January 25, 2006
L-06-003

**Subject: Beaver Valley Power Station, Unit Nos. 1 and 2
BV-1 Docket No. 50-334, License No. DPR-66
BV-2 Docket No. 50-412, License No. NPF-73
Additional Information in Support of License Amendment Request
Nos. 302 and 173 (Unit No. 1 TAC No. MC4645/Unit No. 2 TAC
No. MC4646)**

PRA – Human Reliability and Containment Overpressure

Containment Overpressure Required and Available
CASE 4L DEHL Max SFGDs

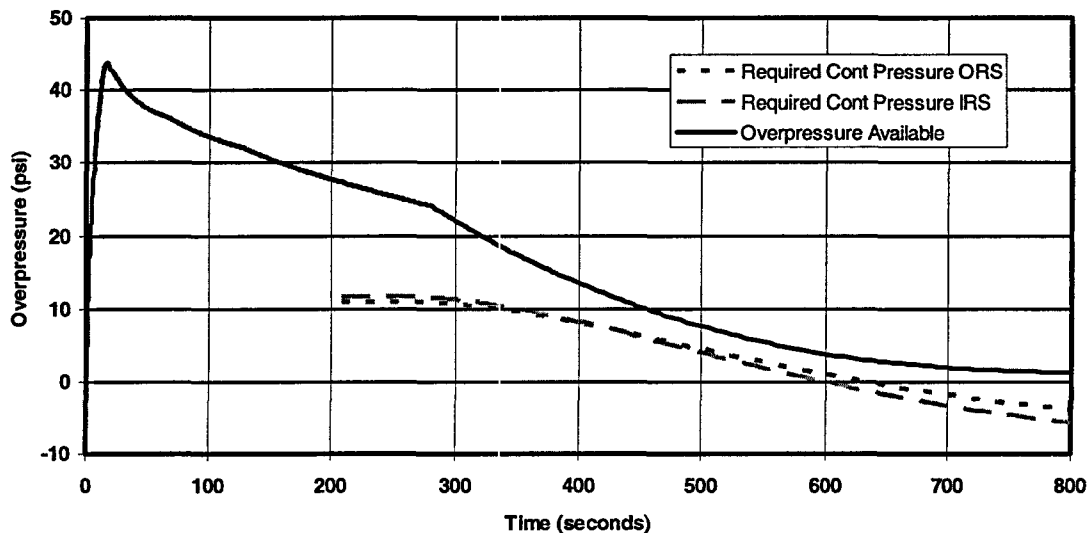
3. What is the current and the requested values of available NPSH for all ECCS and containment heat removal pumps? Provide these values as a function of time and show the amount of time that containment accident pressure is credited for available NPSH. Compare these available NPSH values with the pre-EPU values for both magnitude and duration.

The following plot shows the Containment Overpressure (COP) required for the Inside Recirculation Spray (IRS) pumps and the Outside Recirculation Spray (ORS) pumps, and the available overpressure for this case. The function of the Recirculation Spray (RS) system at Beaver Valley Power Station Unit No. 1 (BVPS-1) is to assist the Quench Spray system in reducing containment pressure following a LOCA and provide containment heat removal. The system consists of two IRS pumps and two ORS pumps which take suction from the containment sump and deliver flow to containment spray headers. The pumps start on a fixed time delay following a high containment pressure signal. Each flow path contains a heat exchanger cooled by service water which provides the only means of containment heat removal for long term cooling of the containment sump water.

The term "COP Required" has been calculated as that amount of pressure above the initial pressure in containment at the start of the accident necessary to ensure that available NPSH equals required NPSH. For this case the initial pressure is 12.8 psia which is the minimum Technical Specification value following implementation of containment conversion.

Figure 1 RCS and Steam Generator Pressures for BVPS-1 SBO11

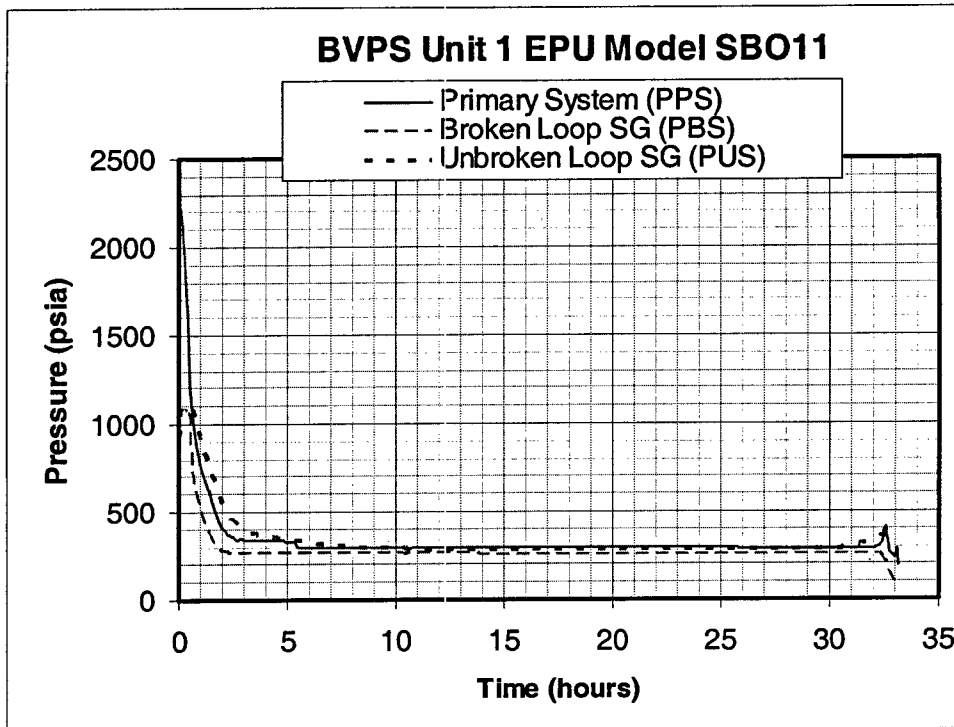
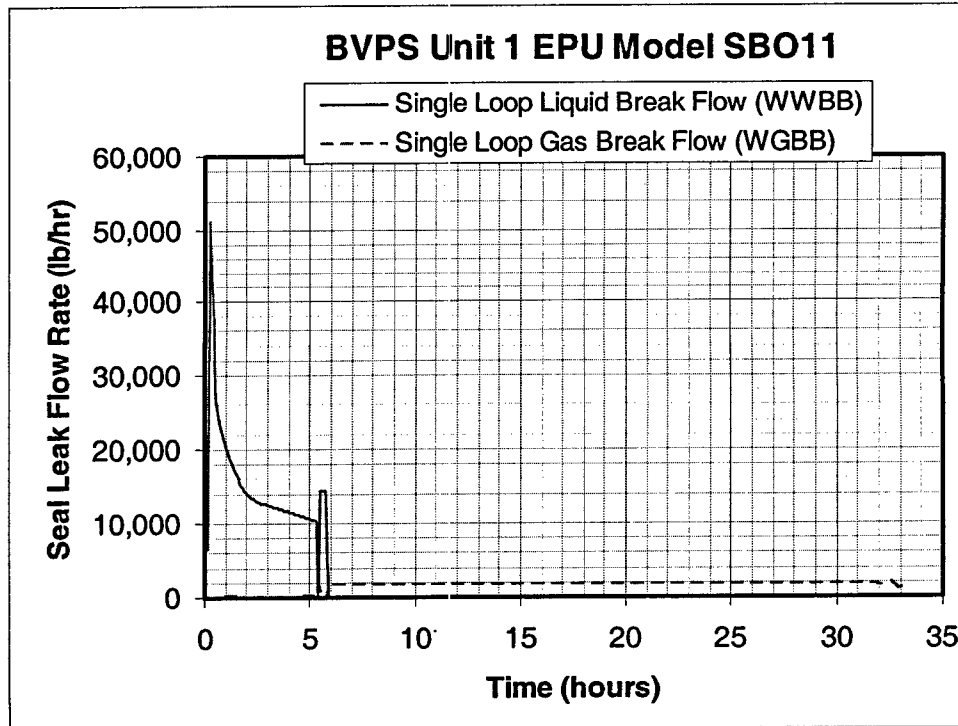
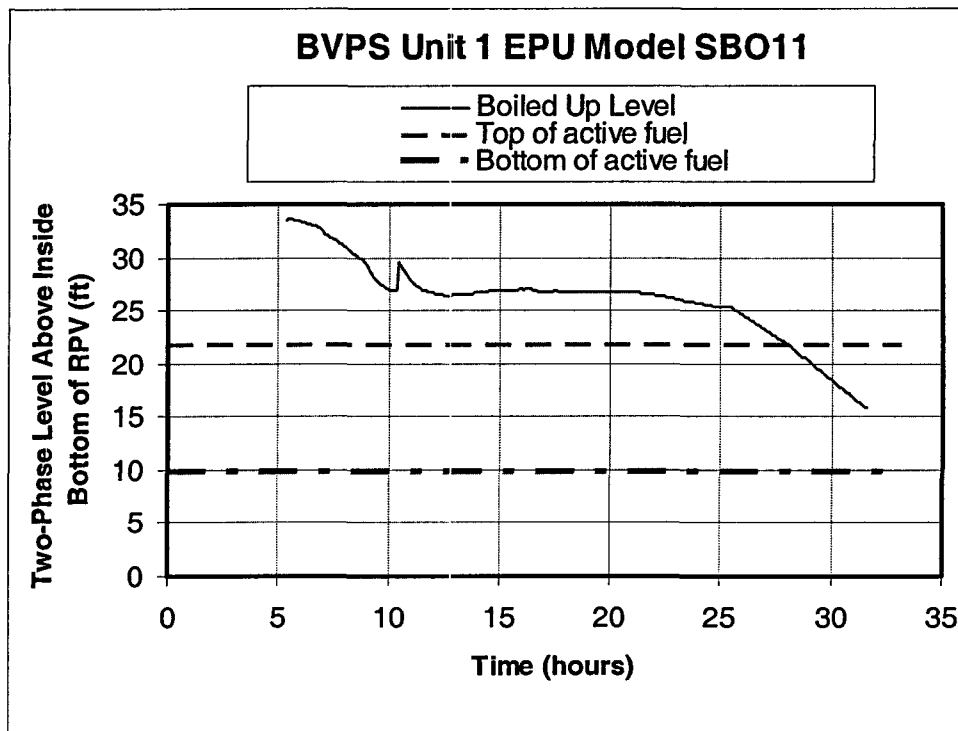
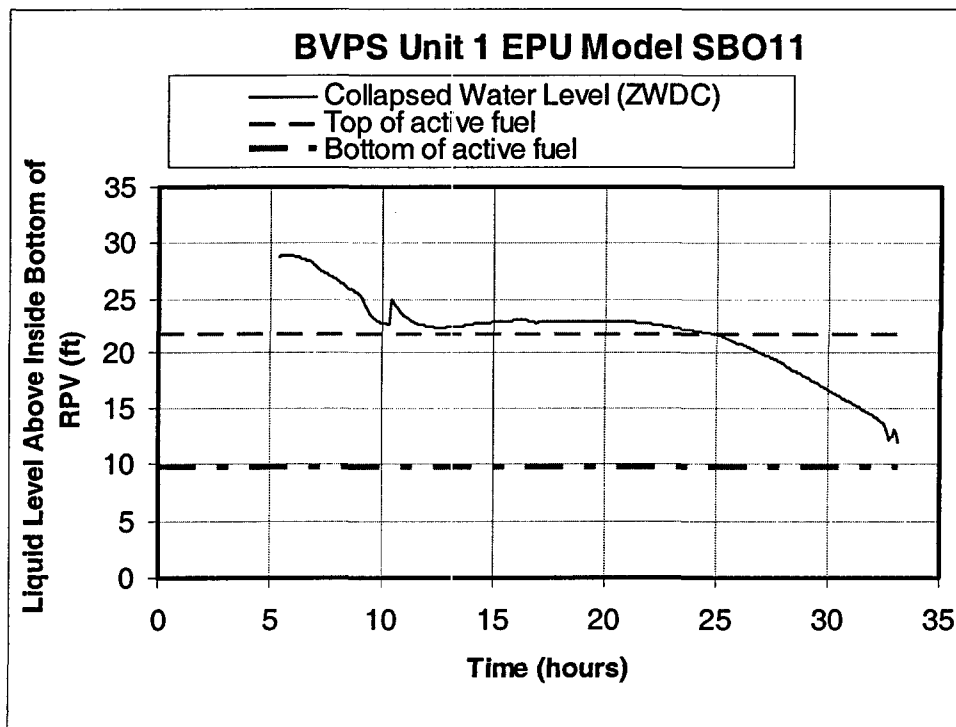
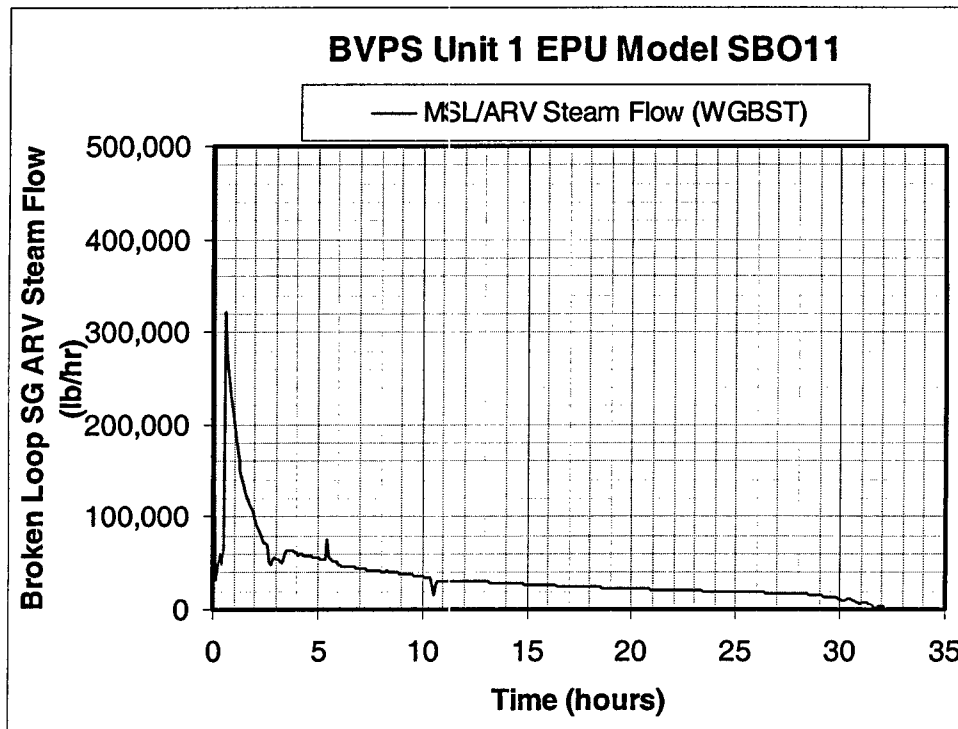
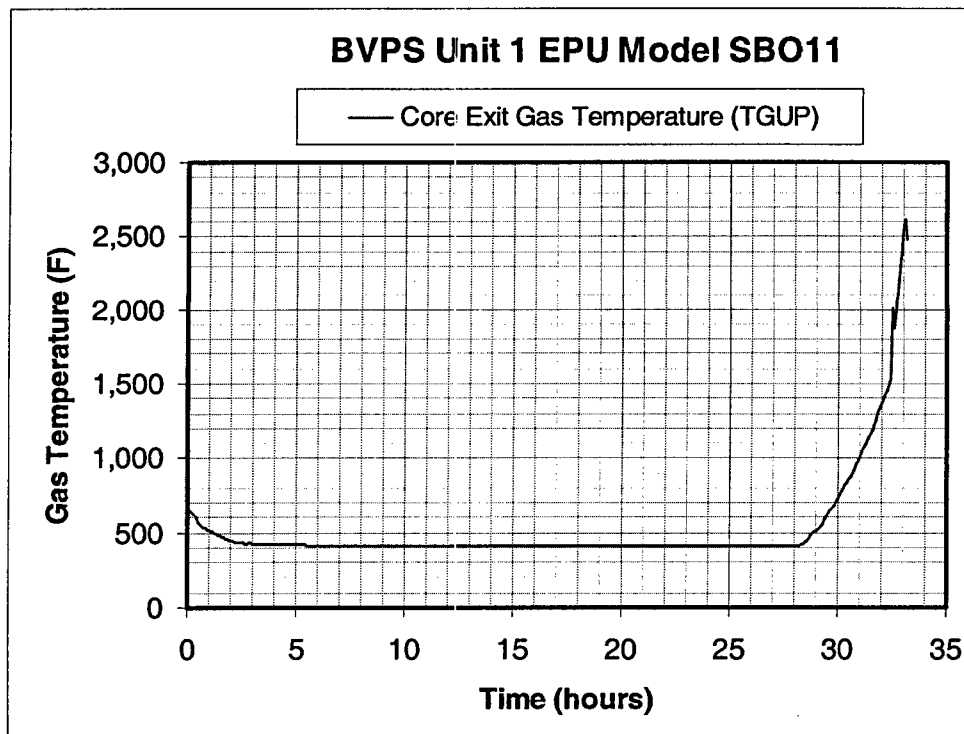
a. Please provide graphs of the following parameters as a function of time:

- RCS pressure (cold leg)
- break mass flow rate
- two-phase level in the inner vessel (show the top and bottom elevation of the core)
- liquid level in the inner vessel
- secondary pressure vs time
- secondary ADV/PORV mass flow rate
- core exit steam temperature
- core normalized power

Additional graphical information regarding the SBO11 sequence and a similar sequence without depressurization (SBO13) is provided in Attachment A “Graphical Information for BVPS-1 Sequences SBO11 and SBO13” of this enclosure. A brief discussion of this additional graphical information follows.

Figure 12: Comparison of the VFOOL Drift Flux Model and FLHT and IIST Experiments.

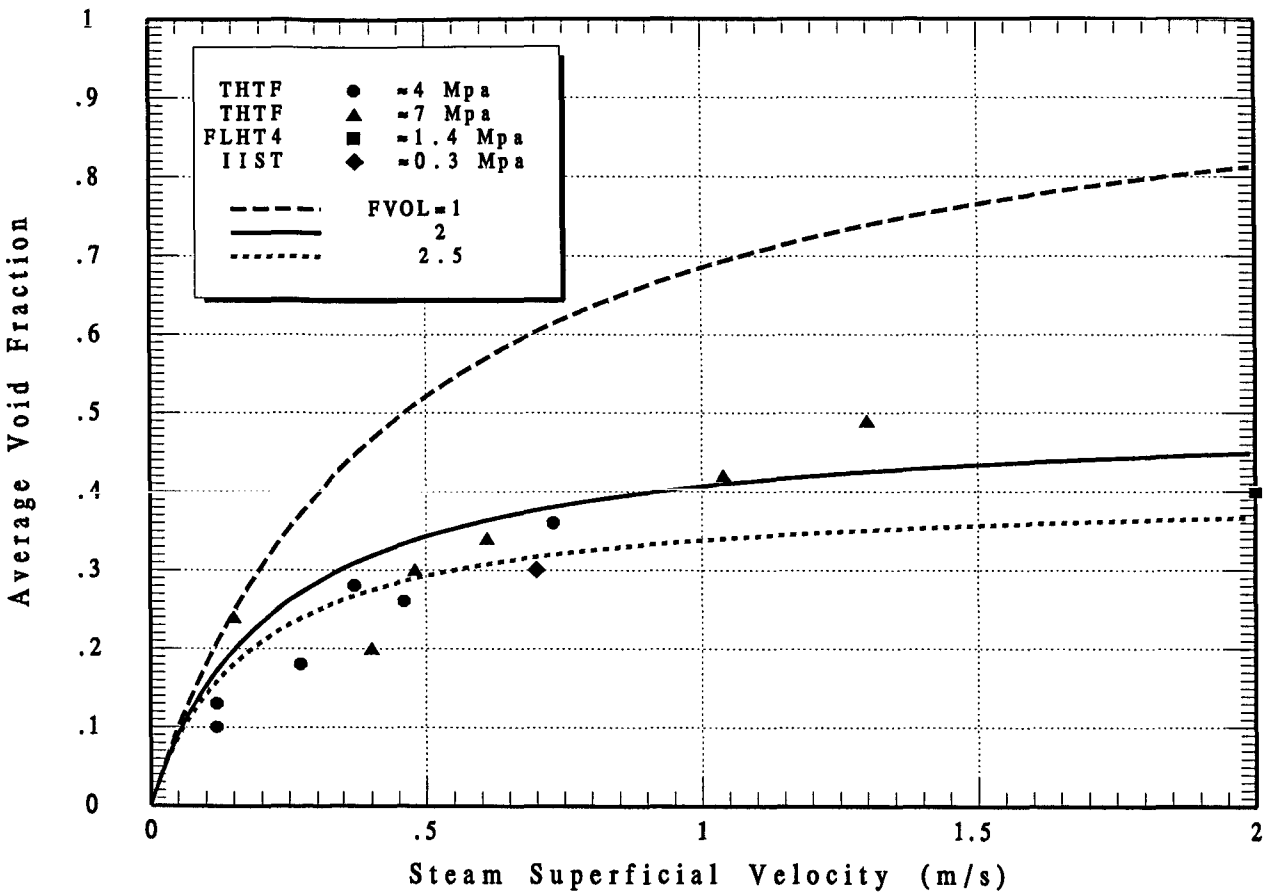
(1) Separate effects test comparisons to demonstrate MAAP can accurately predict two-phase level swell. Please show comparisons of MAAP to level swell tests with heat addition as well as depressurization experiments (see, for example, the THTF steady state uncover tests as well as the 336 rod bundle uncover tests in the G-2 facility, etc.).

(2) Also, please show comparisons of MAAP to SBLOCA integral system experiments that display long term core uncover and heat-up of the fuel cladding to show that MAAP can predict the timing for uncover of the core in scaled systems. See, for example, SEMISCALE Tests S-07-10D, S-U-T8, S-LH-1, S-LH-2, and ROSA-IV test SB-CL-01, etc.). Note: comparisons of MAAP to SBLOCAs that display no core uncover are considered inadequate benchmarks.

1. The nominal value of the drift flux parameter C_0 provide a good representation of the THTF level swell data.
2. As noted previously, there is no pressure dependence of the information at different pressures when interpreted in this manner.

Figure 8 shows the results for test #4 with the boiled-up level being about 3.1 m with the collapsed level at 2.25 m. Table 2 also lists the inlet water temperature at 358 K (85°C) with a system pressure of 1.4 MPa with a saturation temperature of about 473 K (200°C). Therefore, the heated length required to bring the incoming cold water to saturation is about 0.73 m. Substituting this into Equation 9 gives a value for the average void fraction of 0.4 in the saturated region. This is also in agreement with the prediction of function VFVOL for the higher superficial steam velocity of about 2 m/sec. Hence, even with the nonprototypic unheated surface area, the level swell is in agreement with the MAAP4 model as shown in Figure 12.

Reviewing Figure 11a shows that the core is one meter high and that the collapsed water level at the time that overheating occurs is approximately 0.7 m. Consequently, the average void fraction in the core region at the time that overheating occurs is 0.30%. With the power level, cross-sectional flow area and system pressure mentioned earlier, and assuming that the incoming water is saturated, the superficial steam velocity through the heated bundle is 0.69 m/sec. As illustrated in Figure 12, this point is in very good agreement with the results from the full height, full pressure THTF tests which has a similar superficial steam velocity. It is also important to note that this small scale system, has a much larger ratio of unheated to heated surface within the test bundle. As noted earlier, this tends to skew the results towards a lower average void fraction within the heated bundle. Hence, while this lies on the lower boundary considered for the uncertainty in boiled up level calculations, a large core configuration would be expected to have a higher average void fraction than is demonstrated by these scaled tests. Nonetheless, they provide a good representation of the lower bound for the boiled up pool behavior.
